# **Attachment A1(b)**

**Urban Design Study Part 2 – Waterloo  
Estate (South) – City of Sydney**

# The City of Sydney's Alternative Approach

# LAHC Planning Proposal Request

COMPARISON OF SUNLIGHT AVAILABLE TO PARKS

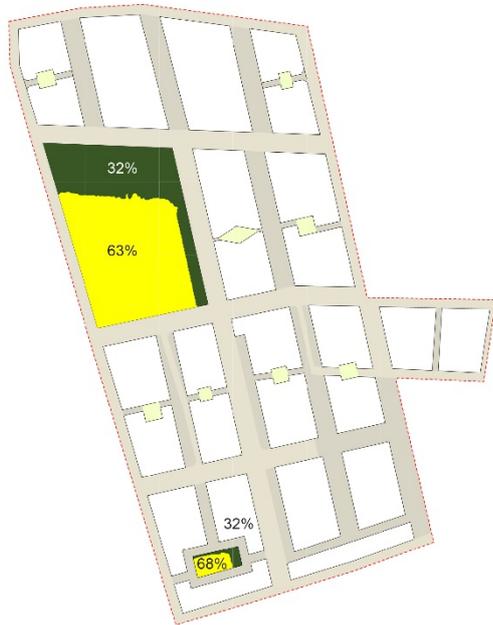
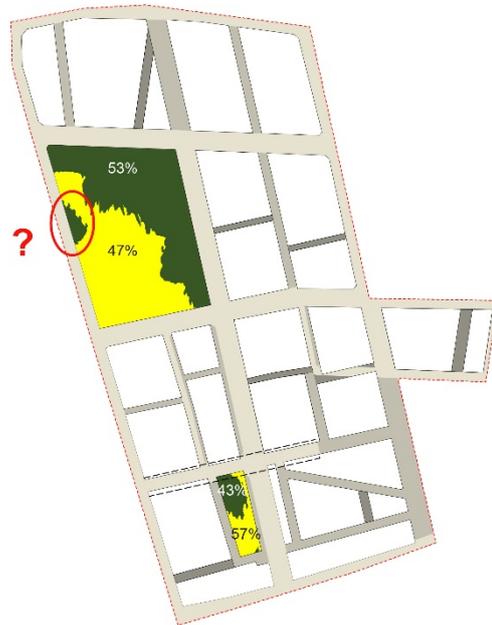
The George Street route was planned by LAHC to be diverted around the estate via McEvoy, Cope and Phillip streets. This is not acceptable to the City and Transport for New South Wales.

To operate successfully the route needs also to be straight and not divert, providing the most direct connection possible. Experience shows that diversions, such as that proposed by LAHC, are not followed by many users who continue to use the straight path to save time. This creates safety problems as fast travelling cyclists leave the pathways designed for their safety and the safety of other road users and conflict can result.

If the bicycle path on George Street was to remain in the Preferred Masterplan it would conflict with park users as George Street in the Preferred Masterplan is included into park areas. The conflict between fast moving cyclists and children playing in parks is a safety problem that can only be resolved by restricting park uses, restricting play in parks is difficult if not impossible to manage.

It was agreed to not move the existing regional bicycle path from George Street and to include the planned regional path along Wellington Street.

**COMPARISON OF STREET NETWORKS – WIDTHS AND SUNLIGHT ACCESS**

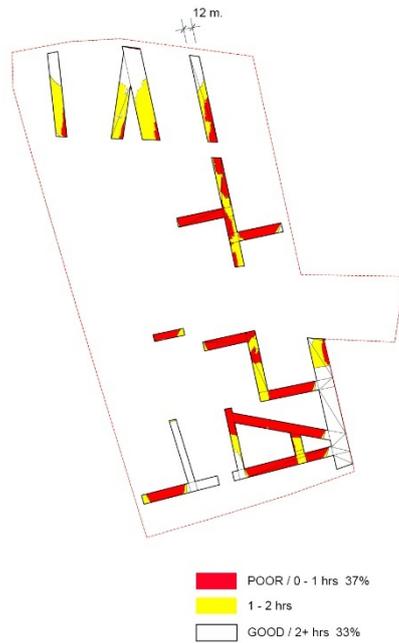
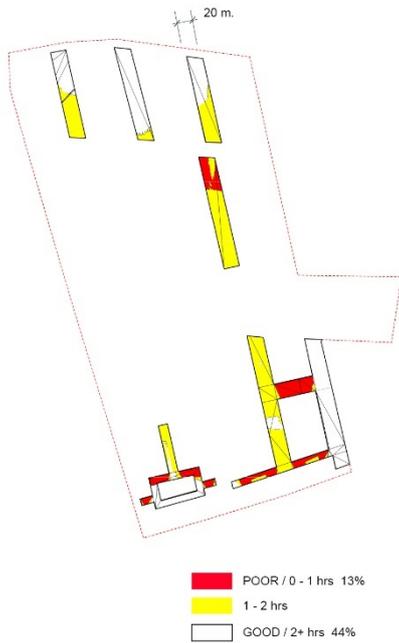
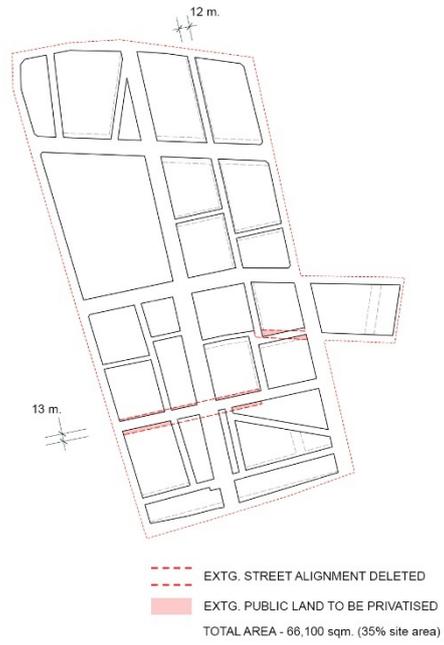
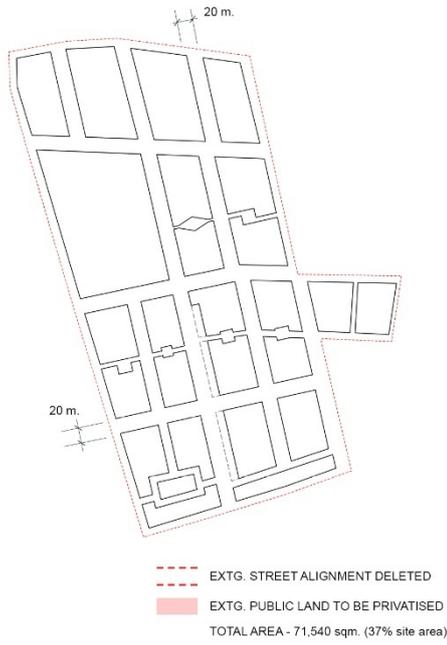
The Preferred Masterplan has generally narrower, with 6 and 9 metre street reservations in a generally 12 metre building to building, new streets evenly distributed in the east west and north south axes. The narrowness and the lack of hierarchy in orientation lessen the access to sunlight in these streets, particularly, in mid-winter.

Within the 12 metre building separation the proposed the street reservations proposed are generally 6 and 9 metres wide. These widths are suitable for shared zones in low use streets – streets that are not required for access to car parks and are located where low [10kph] speed zones are likely to be approved, for example around parks, but not elsewhere.

The Preferred Masterplan includes the narrowing the existing John Street reservation, from 20 metres to 13 metres, to increase the amount of developable land. Implement the narrowing requires a street closure; a complex, time consuming, uncertain legal and bureaucratic process; followed by service relocation and tree removal. John Street is managed and controlled by the City, its agreement to the narrowing was not sought during the design process and is not likely to be agreed. It also proposed closing Reeve Street and reopening it in a slightly different position in a slightly narrower reservation. This is also not acceptable to the City.

LHC agreed not to narrow John Street, not to close and reopen reeve Street and to increase the width of West Street between Reeve and John streets.

**COMPARISON OF COURTYARDS – MID-WINTER SUNLIGHT ACCESS**

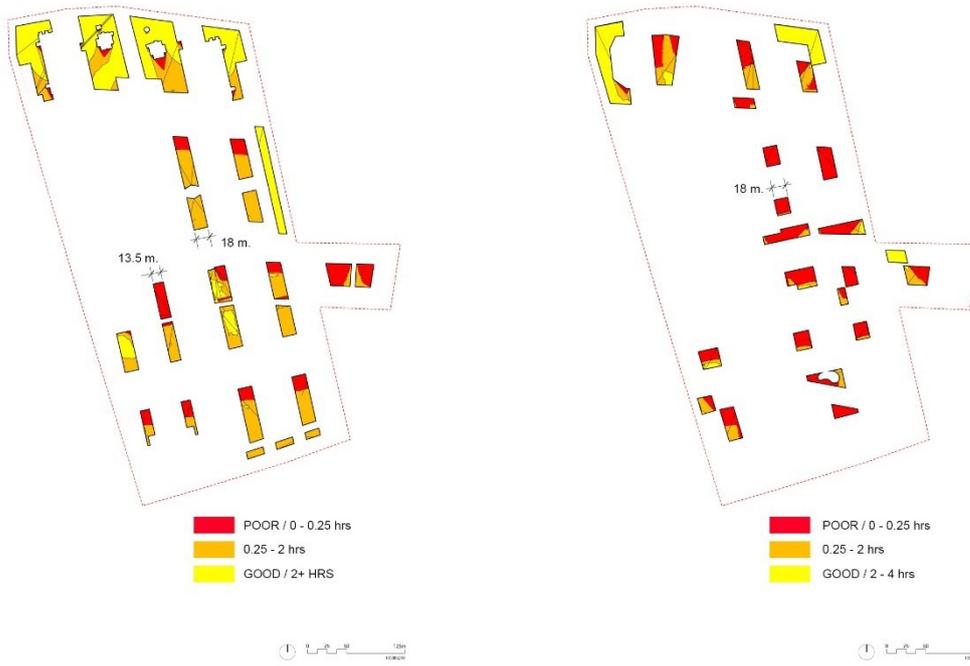
The Preferred Masterplan's courtyards are more often squarish rather than rectangular and consequently are smaller, more enclosed and receive less sunlight.

The City's courtyards receive significantly more sunlight proportionally and in aggregate.

**MATTERS OF CONCERN WITH LAHC's PLANNING PROPOSAL REQUEST**

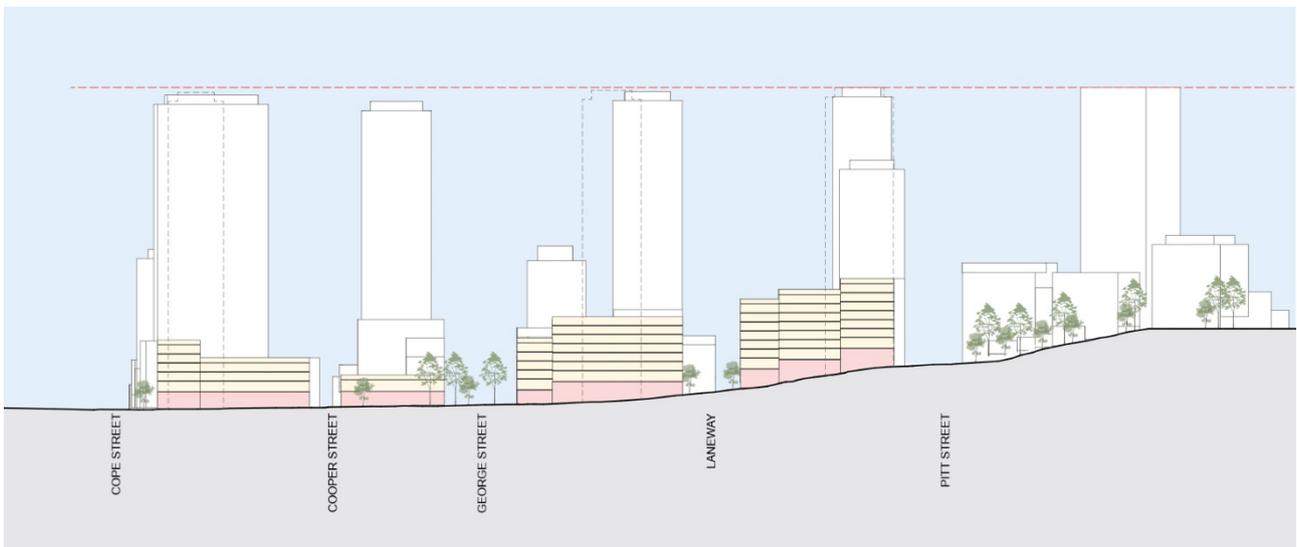
- Some new streets and walkways are not accessible to people of all abilities as they run east west up the slope, rather than north south across it. This restricts access from the west of the site, isolating Pitt, West, Reeve and Kellick streets; and, areas south and west from the Pitt and McEvoy streets intersection, to the park and future Metro station.

- A preponderance of towers; nine towers, eight of around 30 storeys and, in addition, three fifteen storey buildings remain,
  - in some places these towers are located closer together than required by Sydney Development Control Plan 2012

- They do not have sufficient podium setbacks or other measures to protect the surrounding public spaces from wind downdraft
  - They limit sun access to streets, courtyards and lower buildings

- East-west orientation of new street layout limits solar access into new streets, lessening amenity and tree growth
- Some buildings do not meet the building separation criteria of the Apartment Design Guide

- George Street bisects the southern park unnecessarily, decreasing the usefulness of the park while necessitating two new streets either side of it that duplicate the traffic function of George Street thereby increasing the amount of land dedicated to streets

- the parks receive barely enough mid-winter sunlight and risks being undermined in future development proposals.
